SOIL/SITE EVALUATION for ON-SITE WASTEWATER SYSTEM

IMPROVEMENT PERMIT DENIAL

Re: Application for Improvement Permit for property located at 7016 BRANDON PLACE RD , MECKLENBURG, NC 28227
Parcel No.: 13913456
Health Department File No.: SP26-064

Soil & Site Evaluation Map

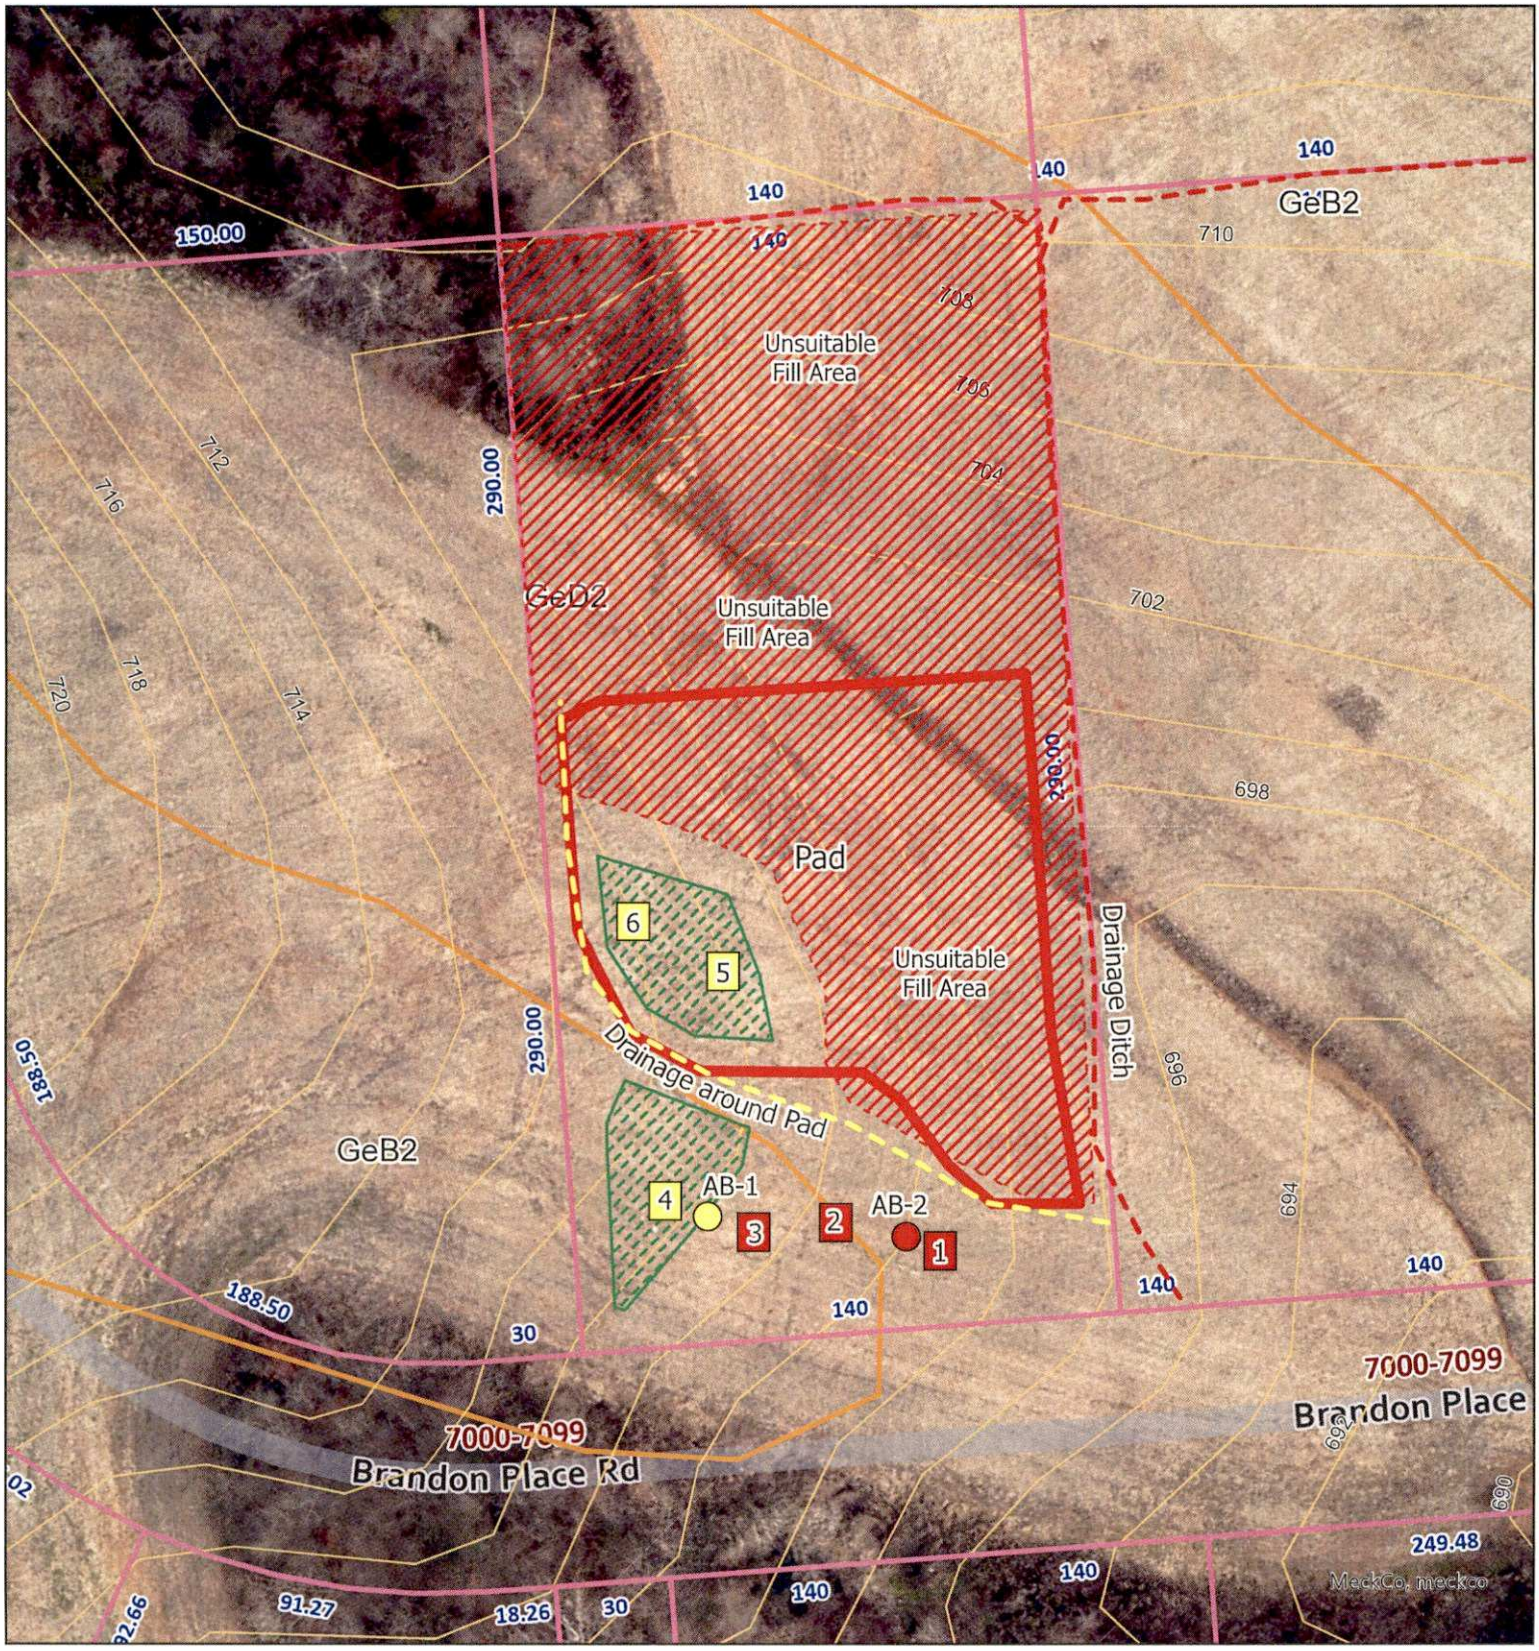
COMMENTS: Due to unsuitable soil depths, unsuitable saprolite, unsuitable fill materials, positive drainage around slab pad, and large unsuitable fill area there likely is insufficient space available to support a 4 BR SFR system and repair area.
